No. EL/3.1.35.17

MODIFICATION SHEET NO. RDSO/2018/EL/MS/0475 (Rev. '2')

Modification in the existing CE resetting scheme to reset the control electronics (VCU) in Multiple Unit Locos.

SHEET No.-1

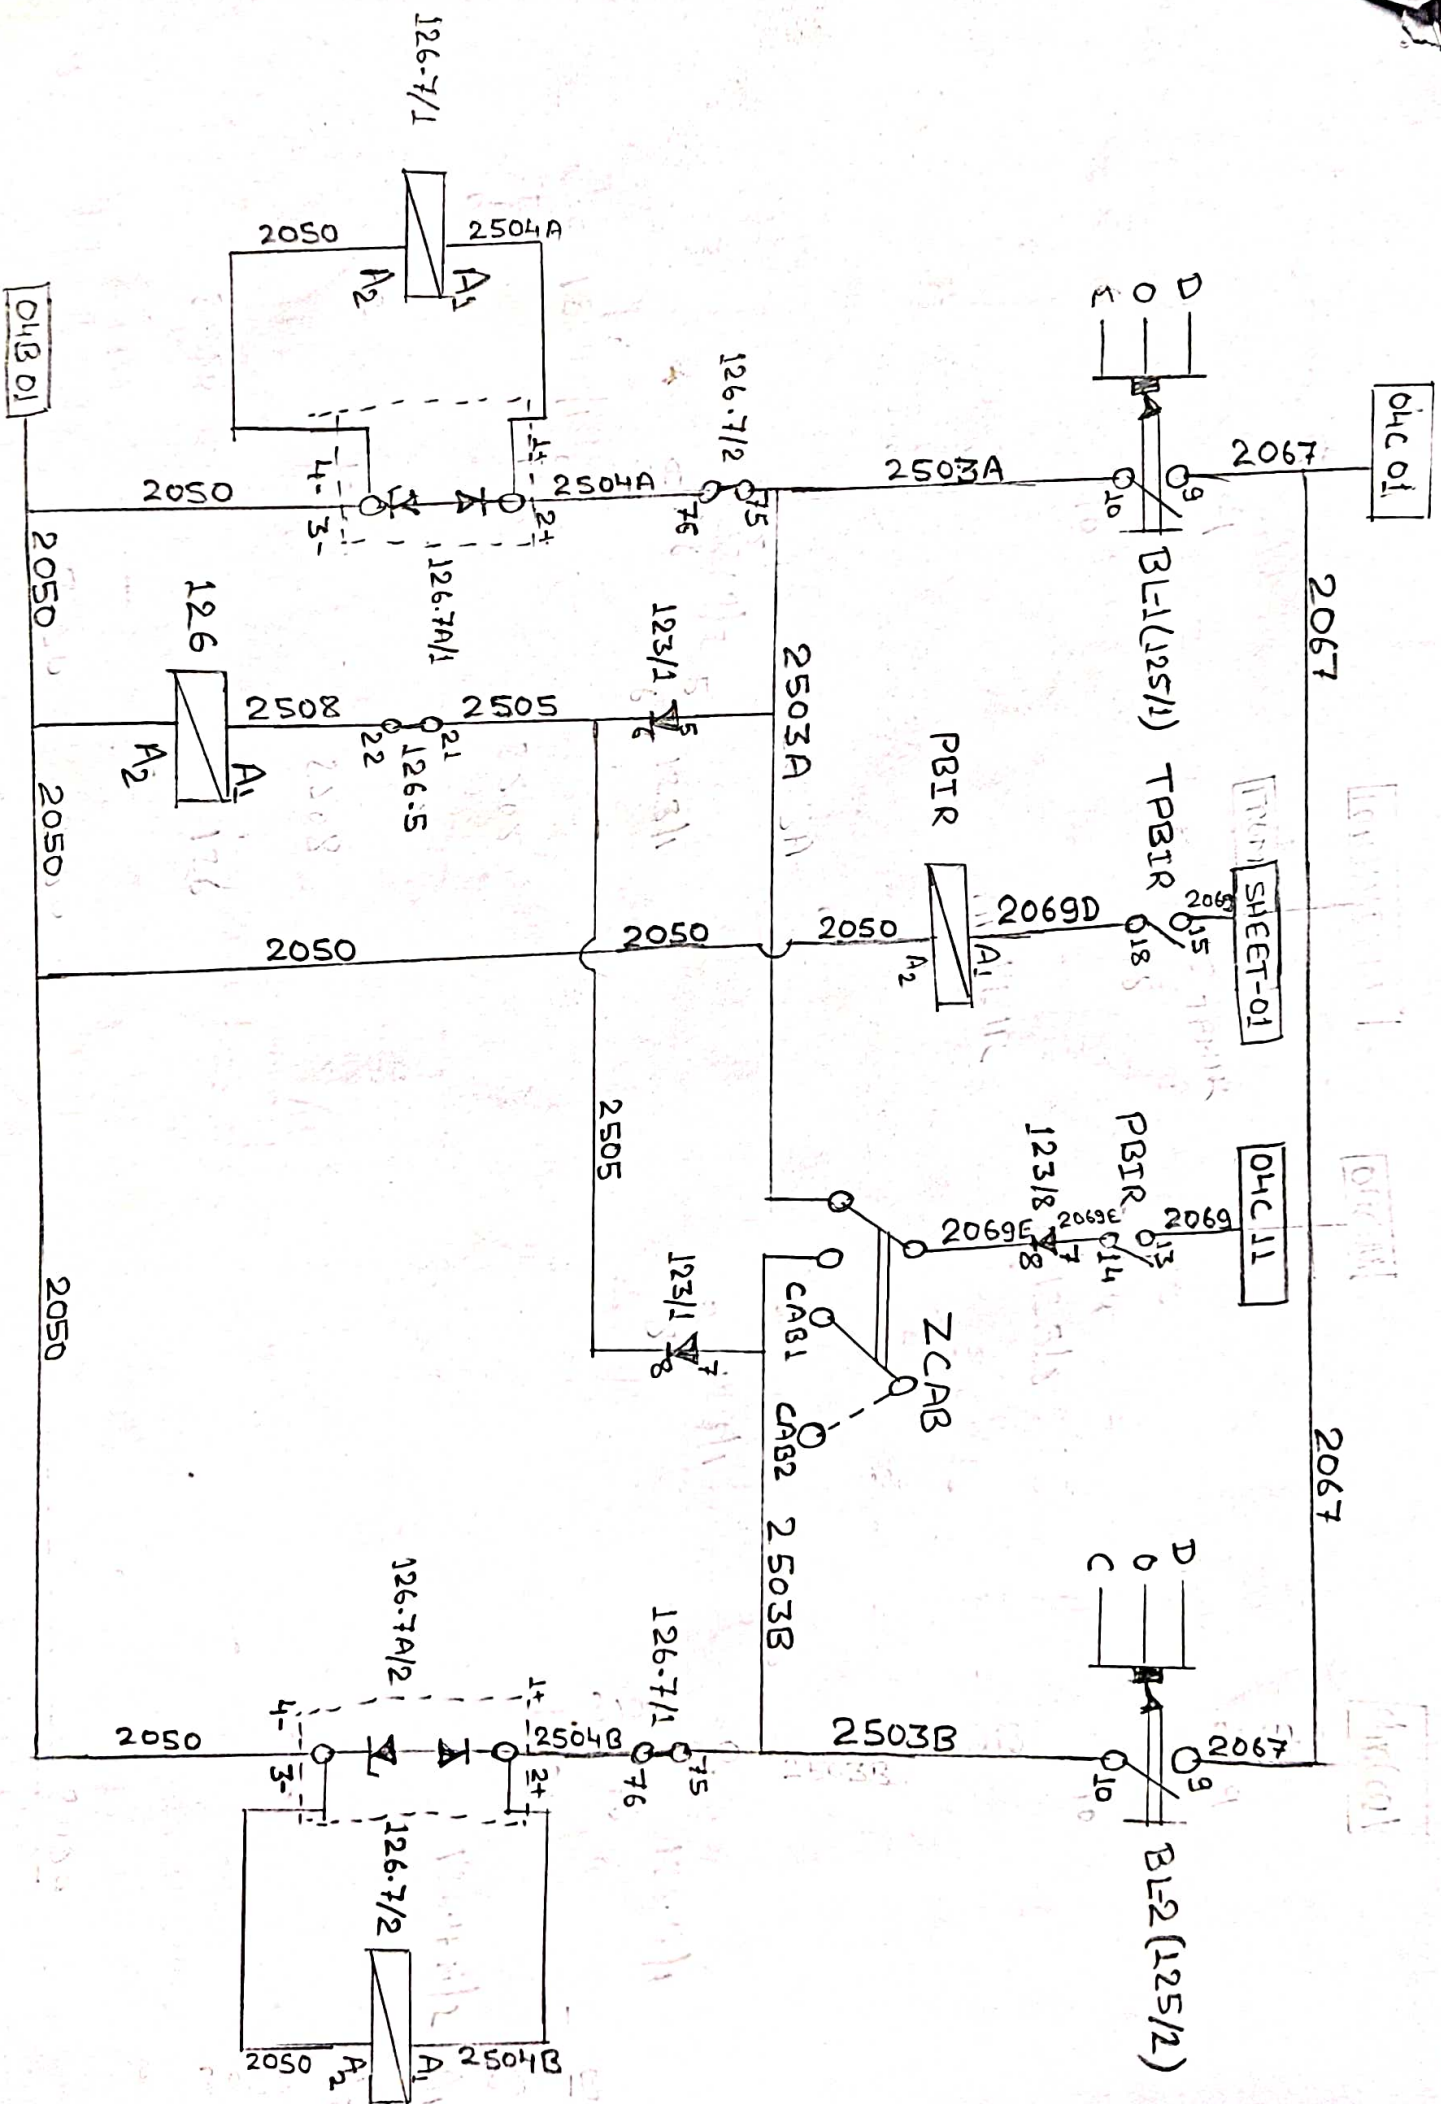
To improve this process, a new modification is proposed that enables the LP to reset the rear locomotive's VCU from the lead locomotive, saving time and reducing effort. The detailed circuit diagrams are enclosed as Annexure.

- Two push-button switches will be provided: "VCU Reset Master" and "VCU Reset Slave" on the D-Panel of each Cab.
- Pressing the "VCU Reset Master" button will reset the VCU of the lead locomotive.
- Pressing the "VCU Reset Slave" button will reset the VCU of the rear locomotive.

- A 60-second time delay relay (Schneider RE17RMMW model) will be installed in SB1.
- When the VCU reset switch is pressed, the relay provides a cab activation signal to the VCU and keeps the Contactor Control circuit (126 and 126.6) in the energized state for 60 seconds, even when BL key is in the "Driving OFF" position.

- A rotary switch in SB1 will allow selection of the active cab in MU formation.
- If CAB1 is the active cab, the Z-CAB switch should be set to CAB1; if CAB2 is the active cab, the switch should be set to CAB2.
- The Z-CAB selection will only be active at the driving end cab of each locomotive, excluding any intermediate cabs.

- The UIC coupler will be modified with additional wiring to pins 1, 2, 3 and 4.
- One end of the UIC cable will connect pins 1, 2, 3 and 4 in one configuration, while the other end will connect pins 3, 4, 1 and 2 respectively.

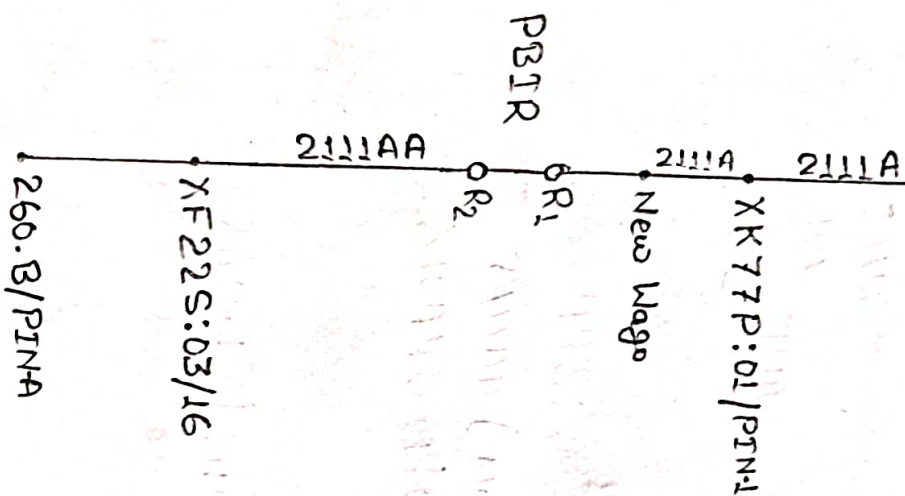
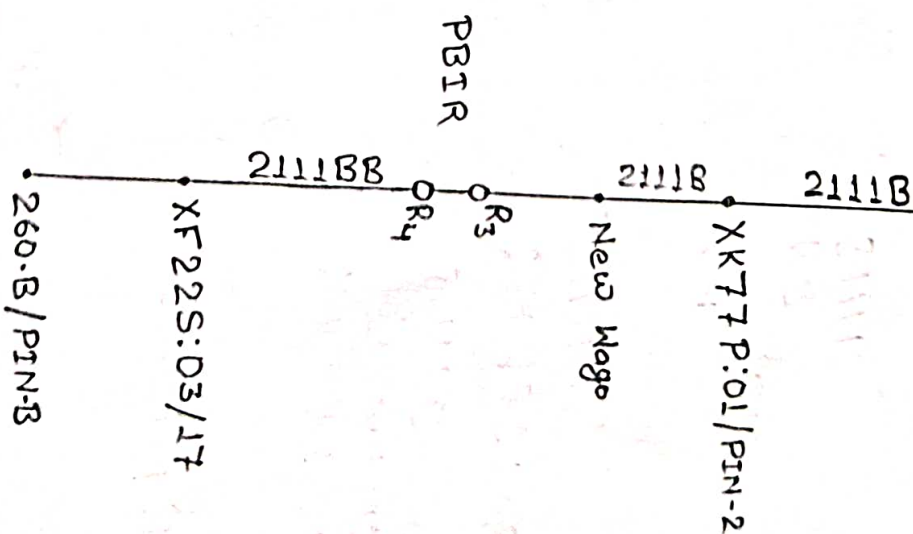
- *For locomotives with CCB-type brake systems (with or without a parking brake), no BP drop is observed in either locomotive during VCU reset.*
- *For locomotives with FTIL brake systems, a BP drop may occur during VCU reset. The modification in sheet no. 5 reduces this BP drop to 2–4 seconds, restoring BP to its normal level of 5 kg/cm².*

TO BE CARRIED IN FTIL LOCO ONLY TO AVOID PRESSURE DROP.
